Date: March 6, 2024
Project: City Refuse Contract Project, Case No. 2022-001263ENV
To: Clerk of the San Francisco Board of Supervisors
From: San Francisco Planning Department
Re: Analysis of Addenda to the Final EIR for the Main Wastewater Treatment Plant Land Use Master Plan

Attachment A:
**Analysis of Addenda to the Final Environmental Impact Report (EIR) for the
Main Wastewater Treatment Plant (MWWTP) Land Use Master Plan**

**ADDENDUM TO THE
ENVIRONMENTAL IMPACT REPORT
FOR THE
MAIN WASTEWATER TREATMENT PLANT
LAND USE MASTER PLAN**

Figure 2: Pilot Project Site Layout

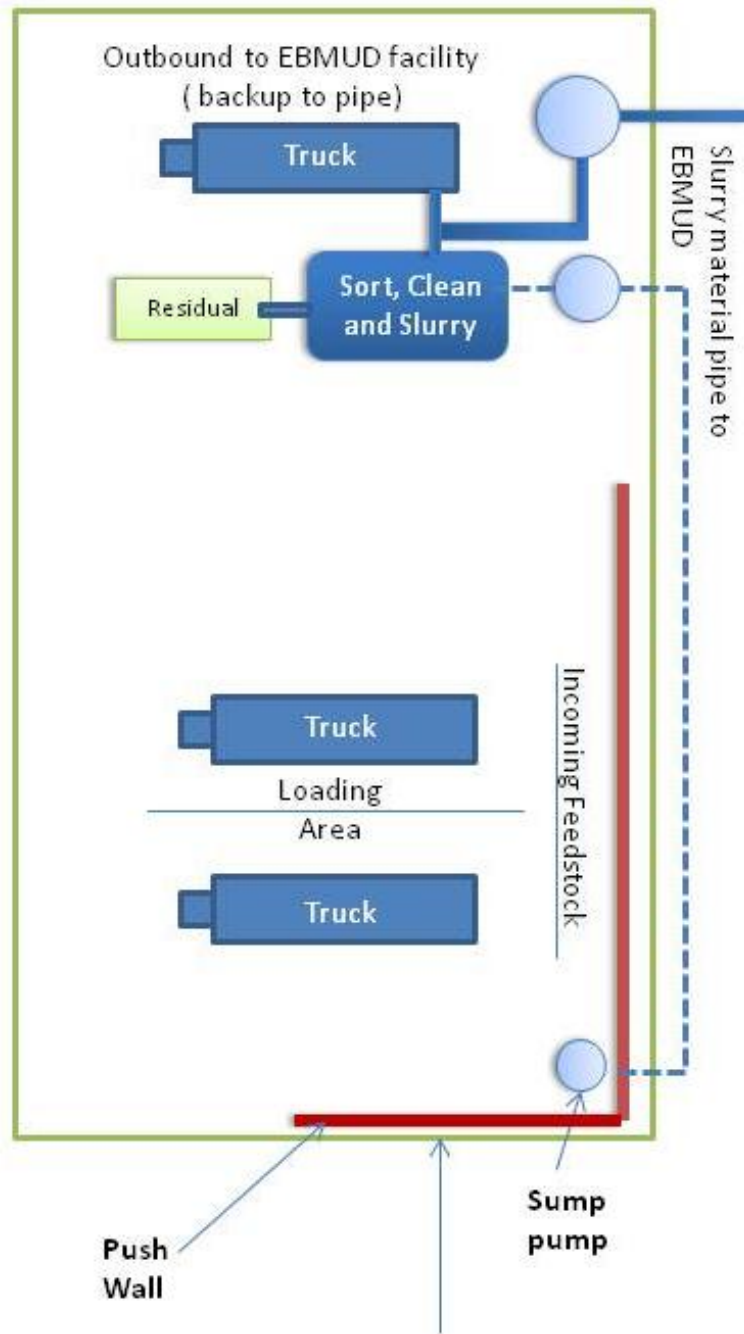
Concrete Pad 120' by 80', sloping towards the sump pump located at the south east corner.

Figure 1: Proposed Site Plan

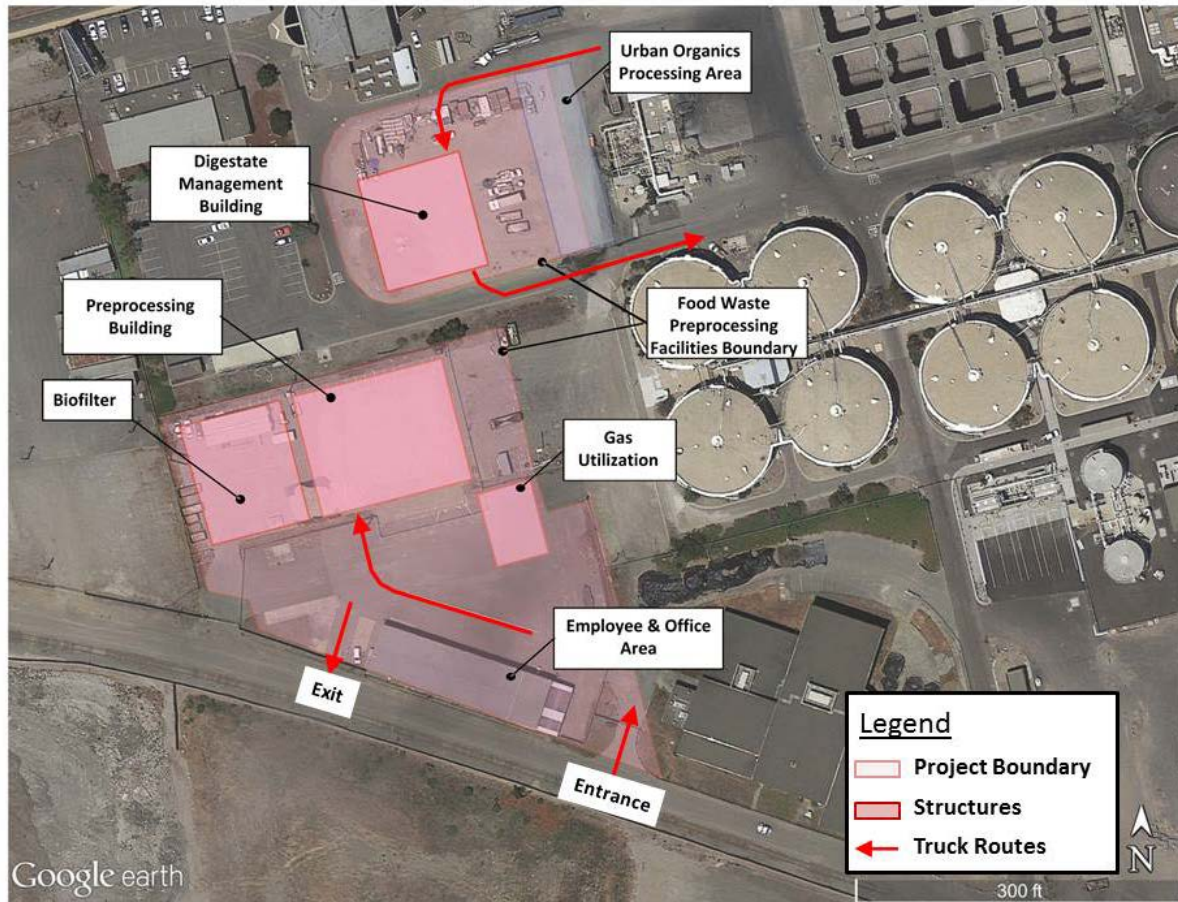
The proposed site layout for these facilities is shown in **Figure 1**. The project would require approximately 2.2 acres (96,000 sf) for the preprocessing facility and 0.9 acres (40,000 sf) for the hydrolysis tank and digestate management building. The full facility build out would involve installation of additional equipment within these facilities.

Gas utilization system – A system to treat biogas generated from the anaerobic digesters would be located adjacent to and east of the preprocessing building (see **Figure 1**). The gas utilization system would draw off biogas from the main digester gas header to produce renewable compressed natural gas for vehicle fuel (BioCNG). The system would include carbon dioxide, hydrogen sulfide, and water scrubbing equipment. The gas utilization system may be operated in parallel with the existing gas utilization system; if an isolation valve is utilized to isolate the biogas produced in the one or more dedicated digesters, an emergency flare would likely be constructed adjacent to the BioCNG facility to prevent the release of biogas in the unlikely event that the CNG facility experiences an unplanned shutdown and the isolation valve to the main gas header fails to open.

Figure 2: Comparison of Modified Project to 2011 EIR

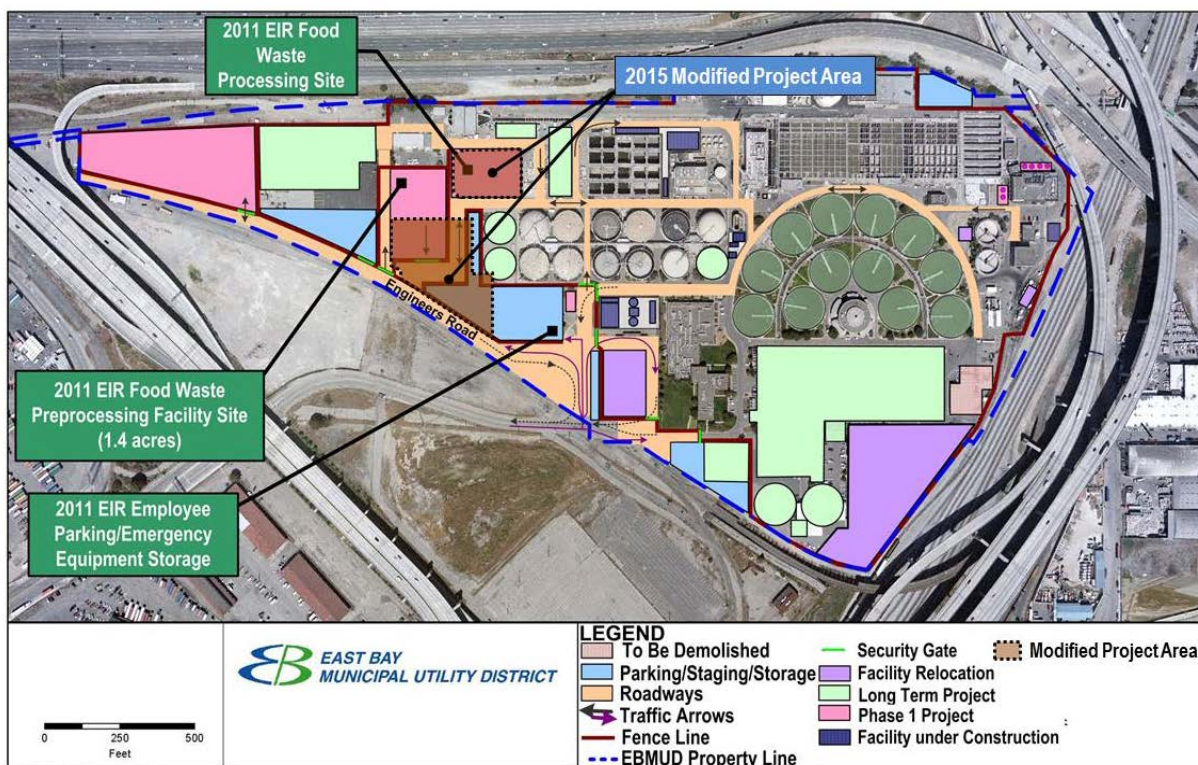
Figure 2 shows the Modified Project footprint overlaid with the layout analyzed in the 2011 EIR. Two new buildings would be constructed as part of the Modified Project. The digestate management building would be on the site of the food waste processing facility described in the 2011 EIR, and the preprocessing building and gas utilization facility would be located partially on the site that was previously considered for the food waste preprocessing facility and partially on the site previously considered for employee parking and emergency equipment storage. Equipment storage is now proposed to be located near the Maintenance Building and employee parking would continue to be distributed throughout the MWWTP, as it is currently. The two buildings would total 27,500 square feet (sf), which is smaller than the 29,000 sf preprocessing building described in the 2011 EIR. Building heights would be similar to the building described in the 2011 EIR.

Figure 1. Site Layout

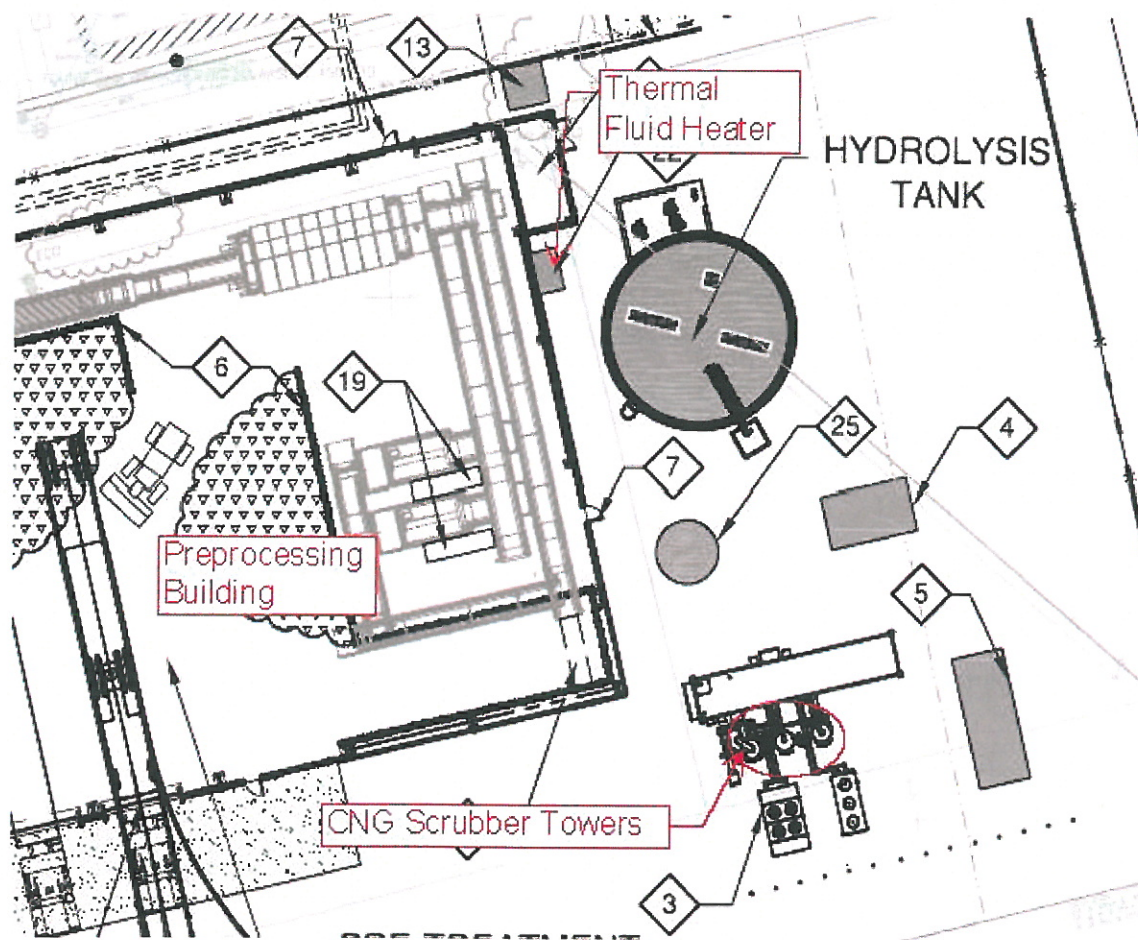
The thermal fluid heater will occupy a space approximately 6.5 feet wide, 6.5 feet long, and 7 feet tall. The heater will be installed between the preprocessing building and the hydrolysis tank, as depicted in Figure 1. The heater will have no effect on the project's aesthetic impacts, due to its relative small size and position surrounded by other, larger structures.

Figure 1 – Modified Project Facilities Location

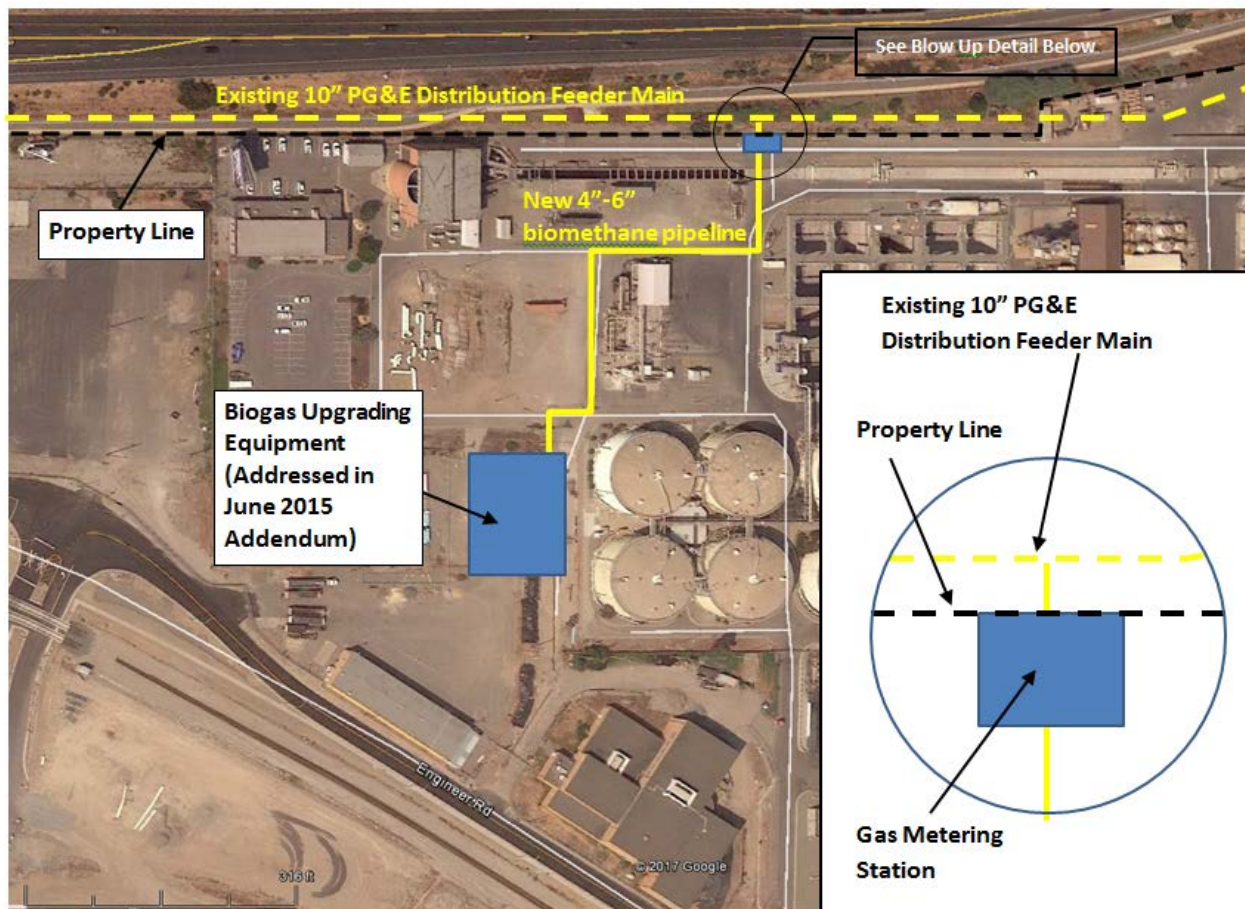
The approximate footprint and location of the facilities are illustrated in Figure 1 below. The pipeline would be constructed using open-cut excavation at a depth of 3 to 5 feet. The new pipeline would connect with the existing PG&E pipeline just outside the fence line of the MWWTP (Figure 2), between the fence and the paved Bay Trail (extending approximately 30 feet outside the MWWTP property boundary on the north). The PG&E pipeline parallels the fenceline at this location.

Figure 2 - Proposed Hydrogen Refueling Station Site Layout

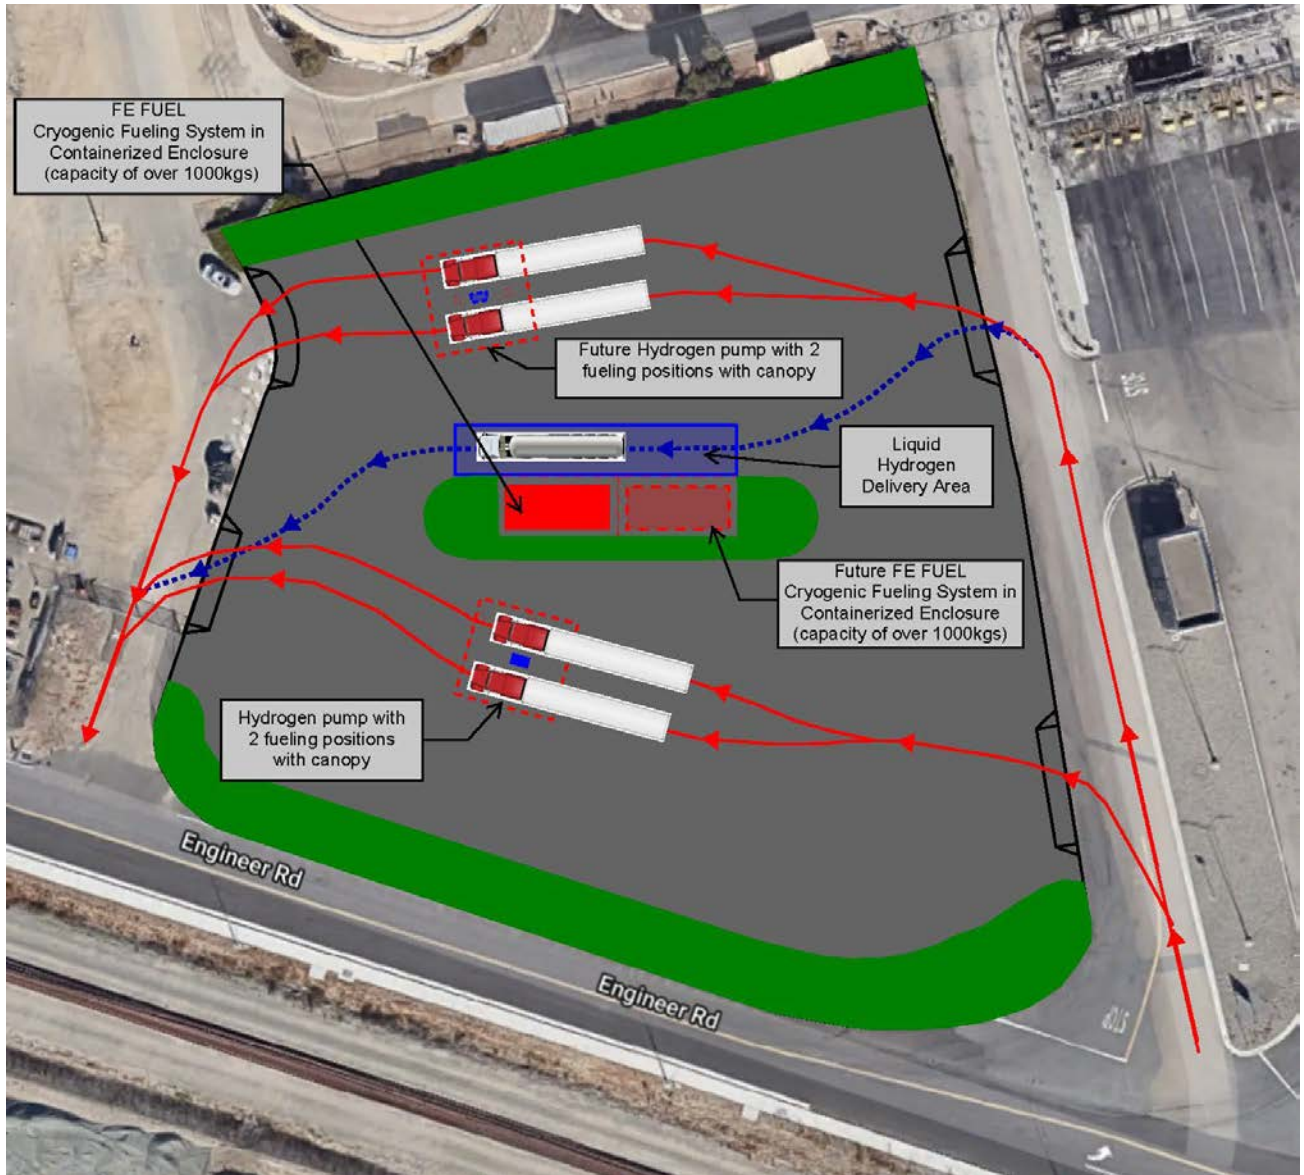
The approximate location of the facilities is illustrated in Figure 1 above, which shows the area for the hydrogen refueling station (HRS). The layout for the station is shown in Figure 2. Equipment would be contained in metal enclosures. The canopy and fueling area would have a finish similar to a typical gas station and would be True Zero branded. Figure 3 shows a typical True Zero hydrogen refueling station with similar equipment and refueling area with a hydrogen dispenser pump with two fueling positions. As shown in Figure 2, the proposed facility would initially have a single cryogenic fueling system and hydrogen dispenser pump with canopy, but if there is sufficient demand a second system would be constructed in the future.
